*REVIEW OF SAFETY, HAZARDS AND RISKS
ASSOCIATED WITH THE
COMMISSIONING AND OPERATION
OF THE SR1 OFF-STREAM EMBANKMENT DAM*

Prepared by Ian Dowsett
Emergency Management Consultant, Retired

Figure 1 Copy of Figure A-3 from STANTEC Report

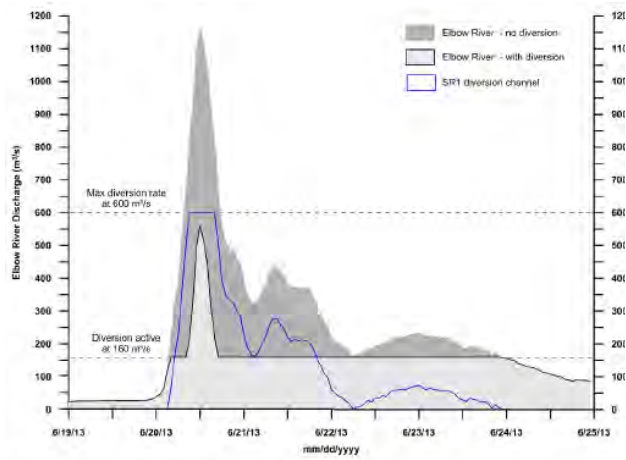
Figure 1 and Figure 2 provide a comparison between the STANTEC model (Stantec, 2018) and the SCLG model. The differences in the outputs are due to differences in the hydrograph data selected¹ and because hydrographic data applied in the SCLG model have been interpolated from graphical plots (Stantec Consulting Ltd., 2015) on 4-hour intervals². As a result, there is a reduction in resolution and the hydrographs applied by SCLG are slightly lower as are the estimated volumes diverted into the reservoir.

The dark grey area on the Stantec plot represents a selected flood hydrograph in the Elbow River applied by Stantec. This area corresponds to **solid blue line** on the SCLG plot. It is noted that the ‘Design Flood Diversion Hydrograph’ shown by Stantec has a peak flow of 1,140 m³/s. As we did not find a comparable hydrograph in their materials, we have applied Figure 8 from the Stantec PMF analysis and adjusted the flows to match the 1,140 m³/s shown in their chart. The actual peak flow for the 2013 flood is 1,240 m³/s.

The **solid blue line** on the Stantec plot rate represents the rate at which water is diverted from the river into the SR1 Reservoir. This line corresponds with **light blue dotted line** on the SCLG plot. In addition, the SCLG applies the diversion rate to calculate and plot the cumulative volume stored during the flood event (the **orange line**).

The light grey area shown on the Stantec plot represents the remaining hydrograph in the Elbow River as water diversion occurs. This light grey area corresponds with **broken pink line** on the SCLG plot. Both resulting river hydrographs clearly show that the peak flow of 640 m³/s bypass the SR1 Reservoir. It is the consequences relating to this peak that is of high concern for our community.

Figure 3 Flood Diversion Hydrograph at the SR1 Off-stream Reservoir - 2013 Flood

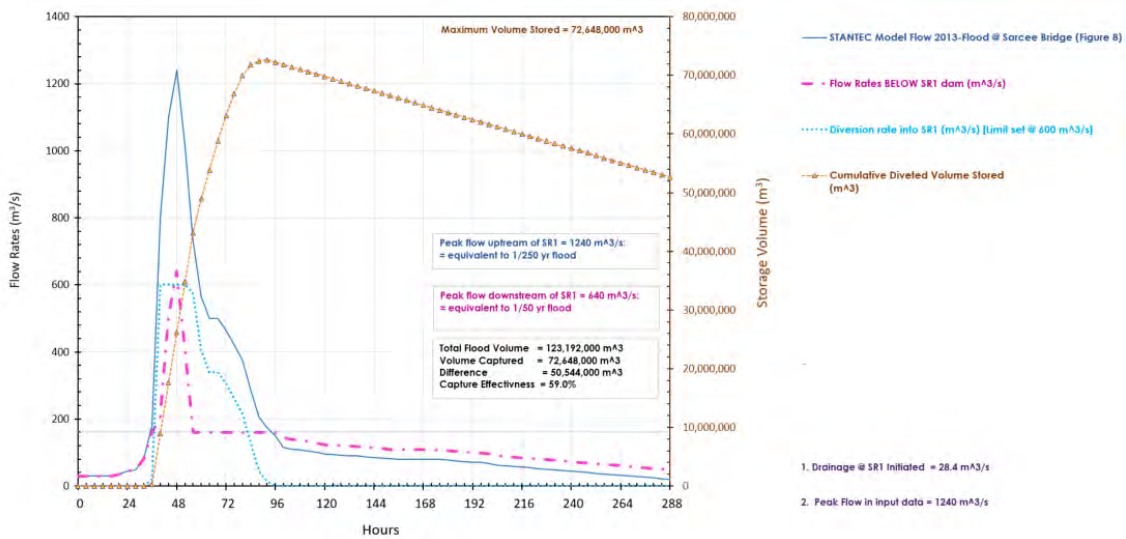
Figure 3 shows: the 2013 flood hydrograph as reported at Sarcee Bridge (the solid blue line); the diversion rate into the SR1 Reservoir (the light blue dotted line); the cumulative volume stored in the SR1 Reservoir (the orange line); and the resulting hydrograph in the Elbow River (the broken pink line). Figure 4 provides similar information at the Glenmore Reservoir. Figure 3 and Figure 4 demonstrates the expected performance of the SR1 Off-stream Project as if operating during the 2013 flood (with a maximum peak of 1,240 m³/s). The results show that the SR1 Project will moderate flood levels in the Elbow River. However, the results also show that the project provides flood protection at two levels:

- Moderated flows, when combined with the additional capacity available at the Glenmore Reservoir, are less than flow rates that will result in flooding. Residents and properties below the Glenmore Dam are protected.
- The SR1 Project does not sufficiently moderate flows in the section of the Elbow River below the SR1 Reservoir and above the Glenmore Reservoir to reduce the peak flow below flood levels. People and infrastructure at lower elevations along this section of the river are not adequately protected and will be subject to flooding. The dam simply cannot divert sufficient water into the SR1 Reservoir fast enough.

Figure 5 Example Hydrograph at SR1 (18% increase)

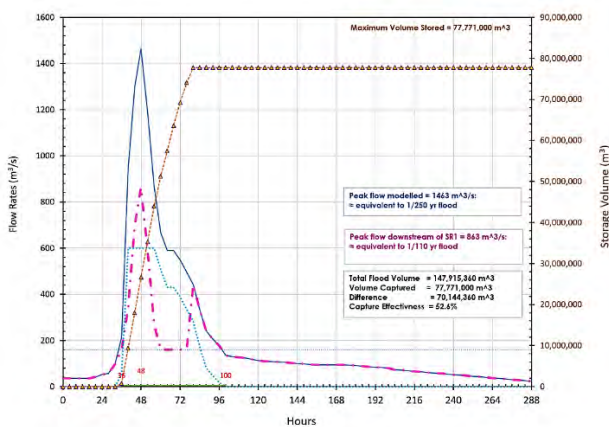
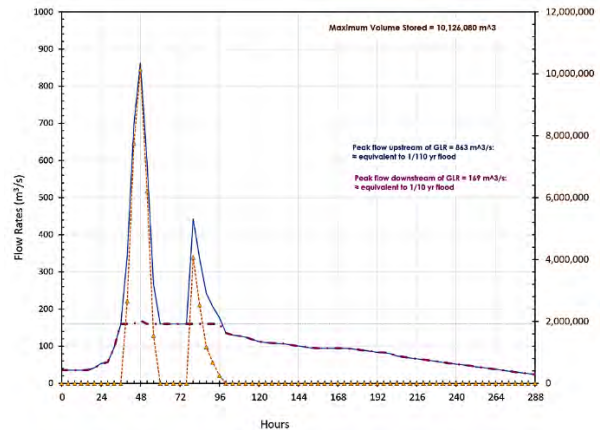
On the basis of our simple model, an increase of 18% (i.e., approximately 1,463 m³/s) in the peak flood rate upstream of the proposed SR1 Project is a sufficient flow rate that causes the first occurrence where flow rates below the Glenmore Dam begin to exceed 160 m³/s. Given all of the variables noted, and considering that the effects of climate change are not factored in, and higher flows are associated with longer flood return periods, is the design adequate to protects us into the future?

Figure 5 and Figure 6, below provide examples of the effects of an 18% increase in the peak flow.

Figure 7 Residences and Properties below the SR1 Embankment Dam (1:50 yr)

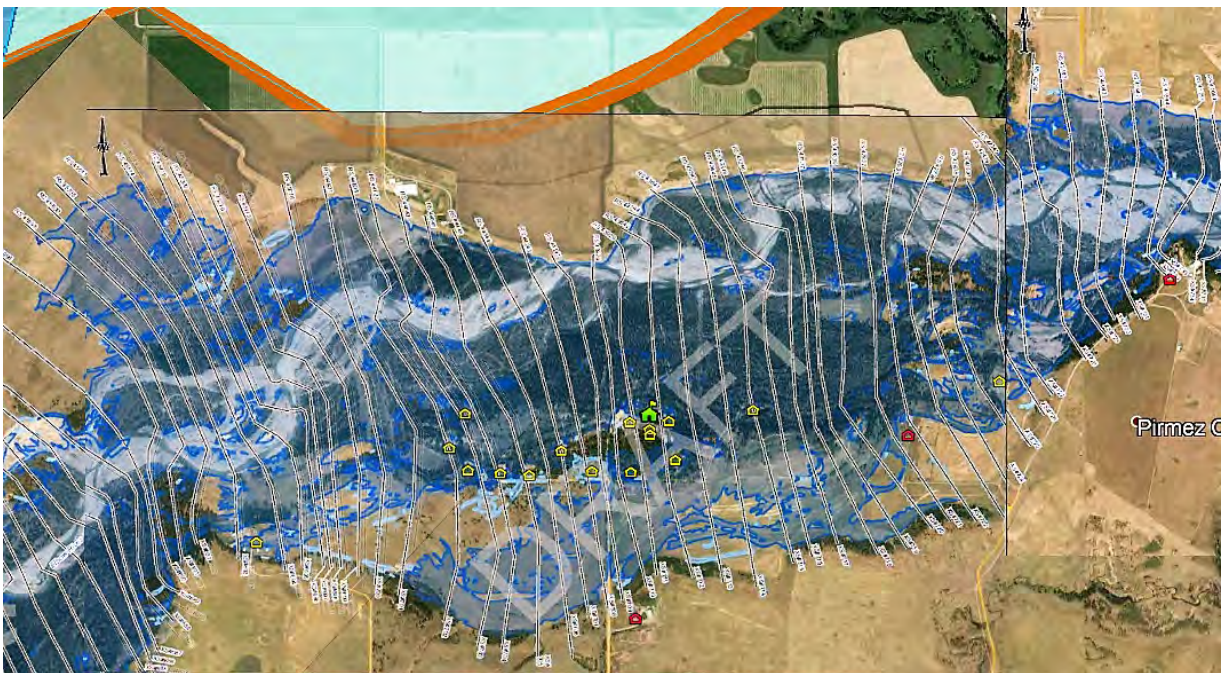
Figure 7 shows a number of Springbank residences and properties located directly below and South of the proposed SR1 Embankment Reservoir. These residents experienced below-ground flooding during the 2005 flood and overland flooding during the 2013 flood. Residences at risk of overland flooding are shown in yellow, below-ground flooding shown in orange.
